DUKE POWER COMPANY

OCONEE NUCLEAR STATION

SECOND TEN YEAR INTERVAL

RESPONSE TO NRC REQUEST FOR ADDITIONAL INFORMATION

OCONEE FLOW DIAGRAMS

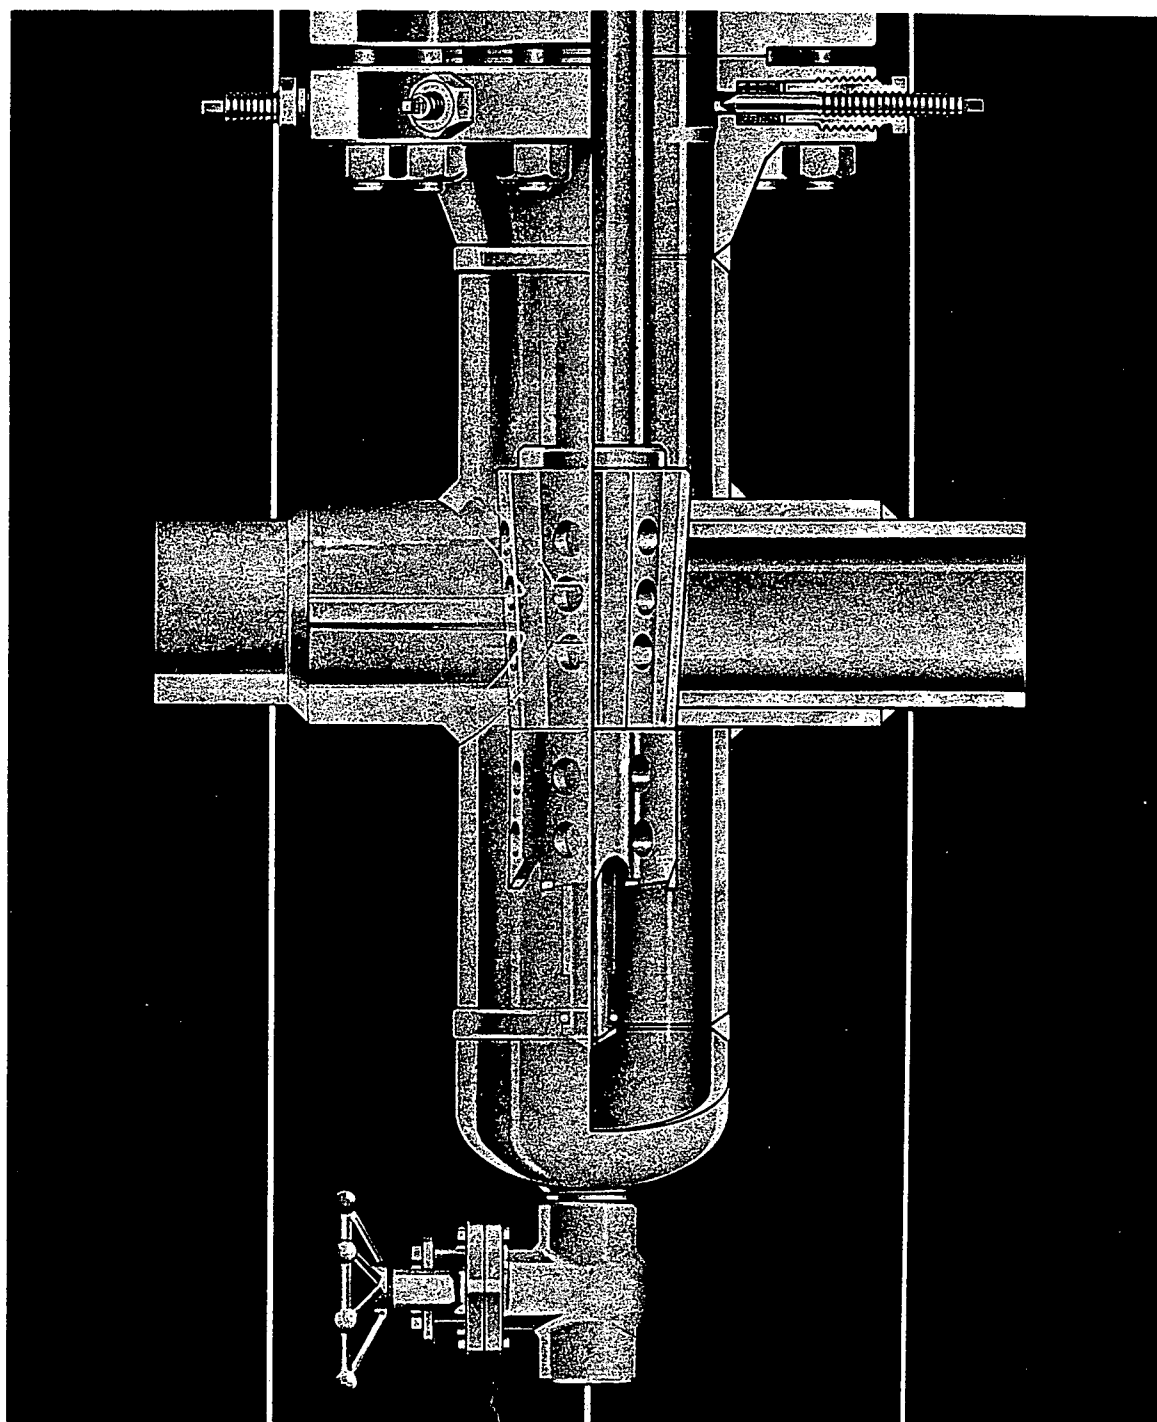
- 5.a 1LPSW 6 is shown at coordinates (L-2) on OFD-124B-1.4, the Marbo Plug is shown on OFD-124A-1.1 (J-B). The Marbo Plug is an isolation device that uses system pressure on the back side to aid in seating the plug. Vendor information regarding Marbo Plugs is attached. A 20" plug is designed for a maximum operating pressure of 750 psi, however, hydrostatic test pressure would be on the upstream side of the plug and thus would cause the plug to unseat.

1LPSW-15 is shown on OFD-124B-1.4 (G-14) and 2LPSW-15 is shown on OFD-124B-2.4 (G-14). The only valve between LPSW-15 and the Condenser Circulating Water system is 2LPSW-71, a butterfly valve. This valve leaks enough that a hydrostatic test can not be performed.

- 5.b 1FDW-207 and 1FDW-209 are the first valves off the 1B steam generator. These valves are shown on OFD-121B-1.5 coordinates (D-1)(1FDW-207) and D-2(1FDW-209). To hydrostatic test the welds on these two valves would require filling the steam generator, main steam line to the turbine stop valves, and the feedwater line to 1FDW-335. This would also result in one additional pressure cycle on the steam generator.
